# American Tin Cannery Hotel and Commercial Project

FINAL EIR | December 2020

## 2 Public Comments and Response to Comments on the Draft EIR

**Figure A -1 Excerpt of Applicant's Section "A-A"**

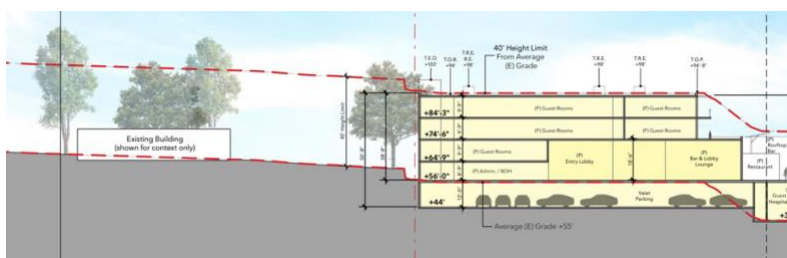
**Ciani Comment A.13.** The proposed Hotel wing at the mid-block of Eardley north of Central (see figure A – 1 on page 9, below) has a roof top elevation of +94' which is about 30 feet above the grade of the adjacent land and can be seen (perceived to be) much higher than the one story buildings depicted in the applicant's cross-section "A-A".

**Fig. A-2 Excerpt: A-13-Site Section C-C**

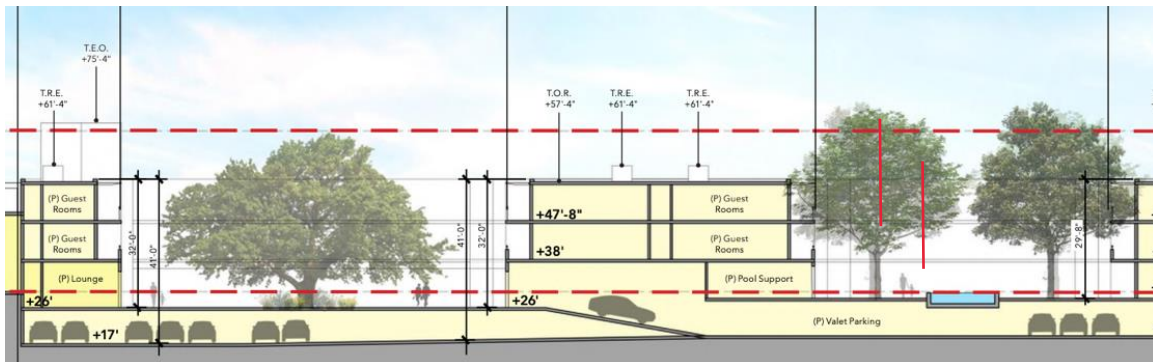
Figure 5-8: Visual Simulation - From Monterey Bay (KVP 8) depicts the trees at the East and west ends of Sloat Avenue, to be the same existing mature trees in both the pre-project and post-project views; which contradicts the specifications to remove and replace them with smaller decorative ornamentals. See Applicant's Landscape Preliminary Plan (ATC DEIR Vol II, page 42.) The "new" replacement tree canopies depicted in the various renderings to be approximately 40 to 50 feet high, are not representative of the size and types specified on the proposed landscape plans. It may not be realistic or possible to plant the trees in the court yards over parking a parking structure as indicated on Section C-C. (See Fig, A-2, P.10)
